SAFETY EVALUATION

RELATED TO LICENSE AMENDMENT NO. 151 TO

FOR MAXIMUM EXTENDED LOAD LINE LIMIT ANALYSIS PLUS MELLA+

NINE MILE POINT NUCLEAR STATION, UNIT 2

Figure-2. Illustration of P/F ratio requirements from Limitation 9.3

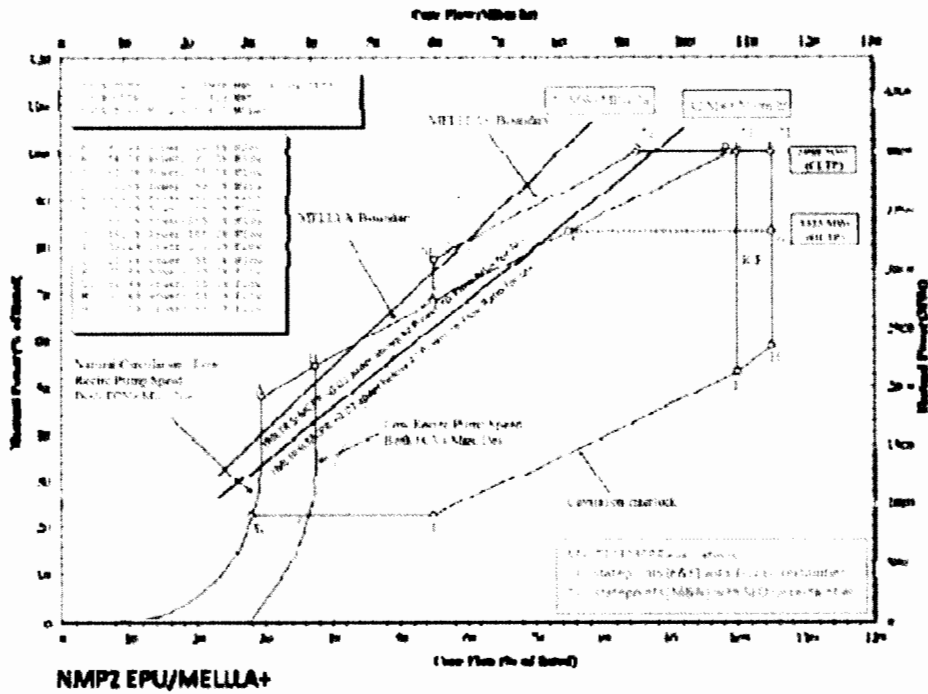
For operation at P/F ratio greater than 50 (for example, at point M in Figure-2), the staff SER required a case-specific evaluation to ensure that the particular plant is not an outlier and has unusual uncertainty values. The staff also required an additional penalty on the SLMCPR by using SLO uncertainties even though SLO operation is not allowed under MELLLA+. This restriction applies to the region in Figure-2 above the 50 MW/Mlbm/hr line, which is a very small area around point M. The staff reviewed on a plant-specific basis the power distribution uncertainties for NMP2. This review was based on a comparison of TIP data provided by the licensee against PANACEA calculated power distributions.

Following the guidelines from Methods Limitation 9.3, the staff has reviewed on a plant-specific basis the power distribution uncertainties for NMP2. This review was based on a comparison of TIP data provided by the licensee against PANACEA calculated power distributions. The TIP data encompasses three cycles from 5/2010 through 7/2014. Figure-3 shows the locations in the P/F map where TIP measurements were performed in NMP2 for the last three cycles (13-15). Analyses of these data show that the power distribution RMS error is between 3% and 7%, depending on the type of uncertainty. A more complete evaluation of the data is provided in Appendix A, RAI-1 evaluation of this SE. The TIP data was provided in the RAI-1 response.

In addition to the 42 and 50 P/F lines (red lines), Figure-2 shows the line in the P/F map where the exit void fraction in the bypass region is supposed to be $< 5\%$ (orange line) based on conservative ISCOR calculations. Bypass void fractions can affect the calibration of LPRM or TIP detectors because they are typically calibrated at full power where there is no bypass flow. The MELLLA+ SER requires that the bypass void fraction be lower than 5% to prevent this de-calibration issue. The calculation shown in Figure-2 confirms that bypass voiding is only a potential problem in NMP2 in a small area around point M (55% flow); however: (1) the void fraction is not higher than 5% at the LPRM location because it is lower than the TIP exit, and (2) NMP2 has committed (Division of Safety Systems, Reactor Systems Branch (SRXB) (2) RAI-1 response dated March 10, 2014), to avoid taking TIP measurements around point M. Therefore, the staff concludes that bypass voiding is not an issue for NMP2 operation in the MELLLA+ domain.
